DiVesta Civil Engineering Associates, Inc.

Re: Roemer Residence – 49 Birch Road, Darien, CT

The following is offered in response to review comments prepared by Mr. Joseph Canas, P.E. of Tighe & Bond, September 2, 2020, regarding the above referenced property.

CHART 1

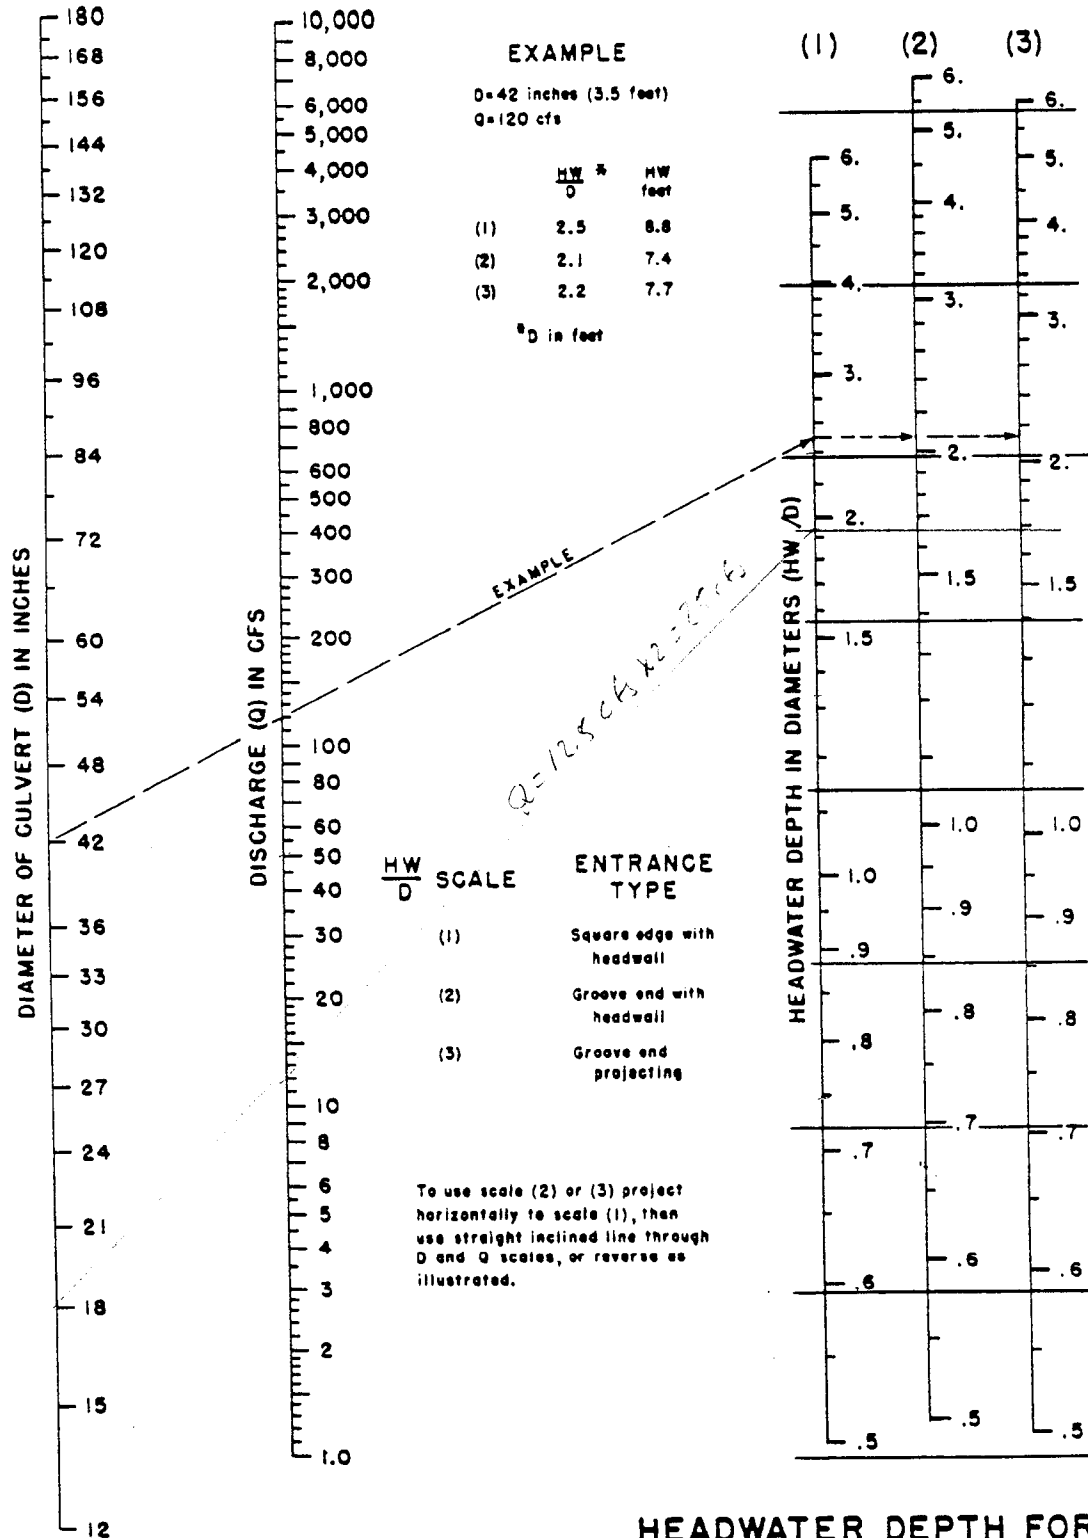
6.
 - a. See the attached worksheets for the Temporary Hydraulic Facilities. Along with the calculation for the inlet control for the temporary brook crossing.
